WM. MOSELY'S PROPERTY SUBDIVISION, **RESUBDIVISION OF LOTS 1, 2 & 3**

APPLICATION NUMBER 7 DATE January 5, 2006

REQUEST Subdivision

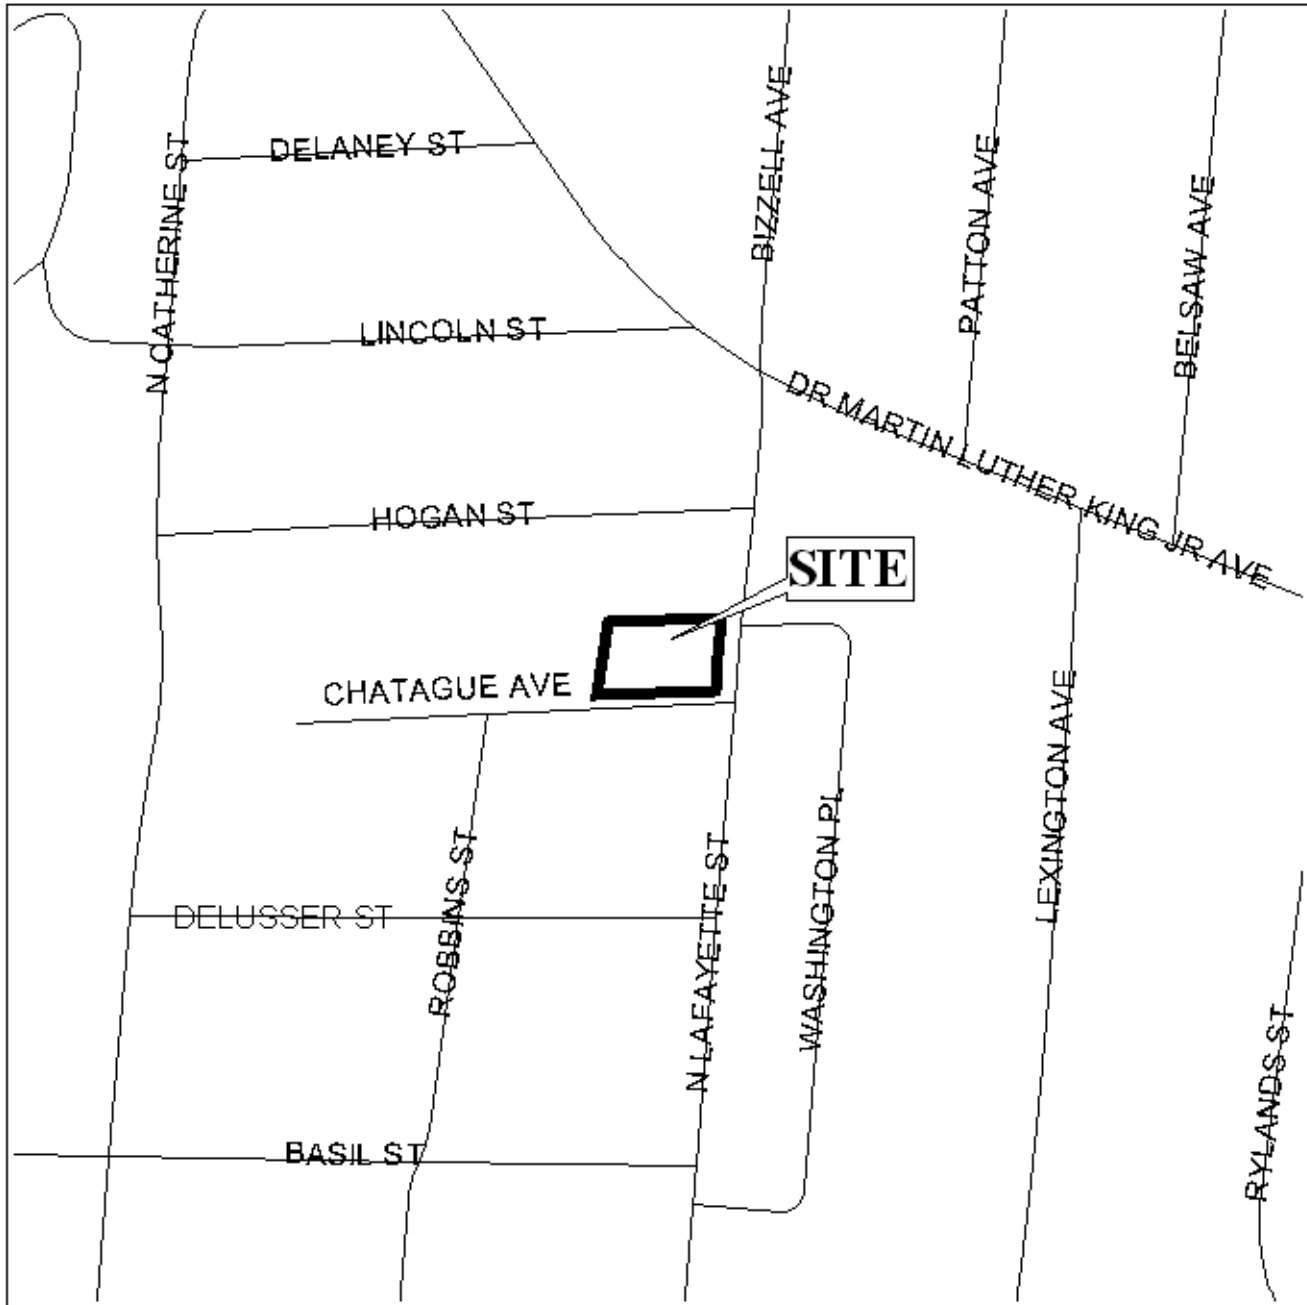
The plat illustrates the proposed 3 lot, 0.4 ± acre subdivision which is located on the West side of North Lafayette Street, extending from Bert Street to Chatague Avenue and is in City Council District 2. The subdivision is served by public water and sanitary sewer.

The purpose of this application is to resubdivide three lots of record.

As shown on the plat, the existing lots are substandard in size. The applicant is simply reconfiguring the same number lots to provide frontage on Chatague Avenue, a substandard street with a right-of-way of 30-feet. Therefore, the dedication of 25-feet from the centerline of Chatague Avenue would be required; thus a waiver of Section V.D.1. of the Subdivision Regulations is necessary. Additionally, as a means of access management, access to Bert Street (a substandard street) is denied. According to City Engineering, there is no documentation of Bert Street ever being opened, paved or vacated. Moreover, the vacation of Bert Street may be a possibility since it is not opened. This would provide the same square footage as would be dedicated.

The final plat should illustrate the 25-foot setback as measured from the property line after dedication.

With a waiver of Section V.D.1., the plat will meet the minimum requirements of the Subdivision Regulations and is recommended for Tentative Approval subject to the following conditions: 1) the dedication of a 25-feet from the centerline of Chatague Avenue; 2) the illustration of the 25-foot setback lines as measured from the property line after dedication; and 3) full compliance with Fire Department comments (*Additional fire hydrants may be required*).
